CHRISTCHURCH DISTRICT PLAN

PLAN CHANGE 14

**PLANNING OFFICER'S REPORT UNDER SECTION 42A OF THE RESOURCE
MANAGEMENT ACT 1991**

Transport

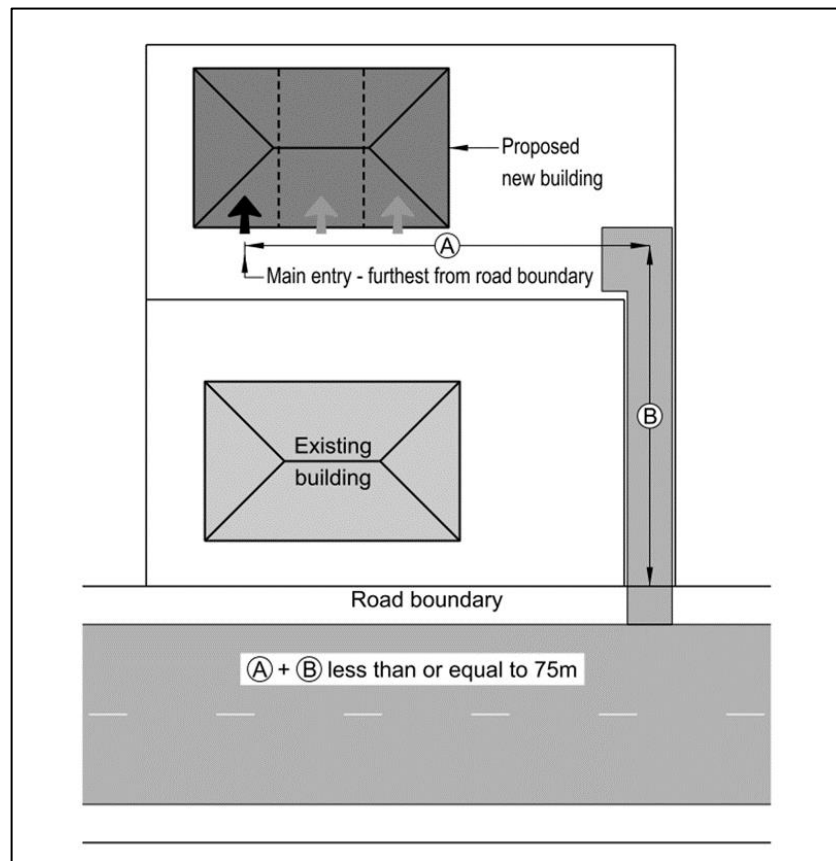
S842.16	Fire and Emergency New Zealand (FENZ)	<p><i>[Insert Figure 7A]</i></p> <p>A+B Less than or equal to 75m</p> 	Accept in part												
S842.17	Fire and Emergency New Zealand (FENZ)	<p>Amend as follows: Table 7.5.7.1 – Minimum requirement for private ways and vehicle access:</p>

- 8.4.11 To assist plan users and provide clarity in relation to Appendix 7.5.7 (h)ii, a conjointly developed diagram is requested to be included by **FENZ (S842.16)**

8.4.8 “For the purposes of access for firefighting, where a building is ~~either~~: i. located in an area where no fully reticulated water supply system is available; or ii. located further than 75 metres from the nearest road that has a fully reticulated water supply system including hydrants (as required by NZS 4509:2008). **75 metres is measured from the road boundary via an existing or proposed property access, to the main entry furthest from the road (Figure 7A); or iii. located in the Residential Hills Precinct and is a residential unit on a rear site,** vehicle access ~~shall have a must be a~~ minimum formed width of ~~3.5~~ **4** metres **for its entire length**, and a height clearance of 4 metres. Such vehicle access shall be designed **and maintained** to be free of obstacles that could hinder access for emergency service vehicles”.

8.4.9 The amendments to Appendix 7.5.7(h) by **FENZ (S842.15)** have also been considered William Field from the Urban Design Team at CCC in his evidence report. Based on the presented evidence, it is recommended to have a minimum formed width of 3.5 metres for the entirety of the length of the accessway with 0.6m on either side to provide for boundary amenity planting and foundation planting along residential unit edges as set out in 14.15.1(c)(D) - Residential Design Principles. This foundation planting provides for privacy separation from windows that are ideally located along driveways for passive surveillance reasons. Accordingly, the expert proposes a 4.2m minimum width. In turn, the proposed vehicle access width seeks to ensure that amenity values are maintained for new developments as set out in Section 7(c) of the RMA. However, the proposed vehicle access width and minimum formed width as proposed by the expert would insufficiently accommodate access for mobility impaired people as discussed in the evidence report of Mr Rossiter.
